TWO-JOINT DIFFERENTIAL TX BANK - REVIEW CIRCUIT r0.1

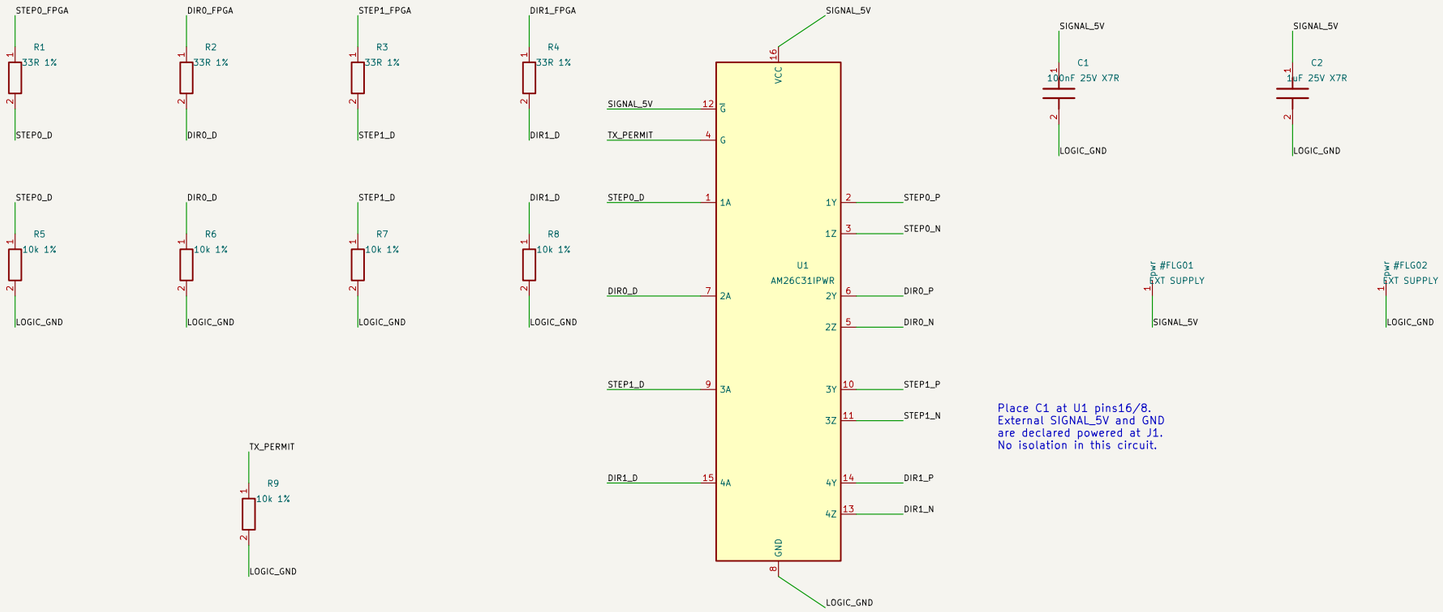
Repeat 3x for six joints. No PCB, external protection or system inhibit circuit is released.
U1 pin map checked against TI SLLS103P Figure4-1 (PW16). Supply4.5-5.5V; logic VIH>=2V/VIL<=0.8V.

3.3V source required; no 5V pull-up on FPGA-connected nets. Inputs must not drive an unpowered U1.
R1-R4 are initial source-damping provisions; R5-R9 force low with upstream high-Z. Re-evaluate SI in layout.

Place C1 at U1 pins16/8.
External SIGNAL_5V and GND
are declared powered at J1.
No isolation in this circuit.

G=0 and /G=1 -> differential outputs HIGH-Z. TX_PERMIT must come from qualified hardware permission.
HIGH-Z is not guaranteed STEP-low at the remote drive: qualified receiver bias and drive inhibit are mandatory.

J1/J2 are circuit boundaries,
not approved connector MPNs.
Missing line protection,
remote bias, power sequencing
and cable qualification block release.
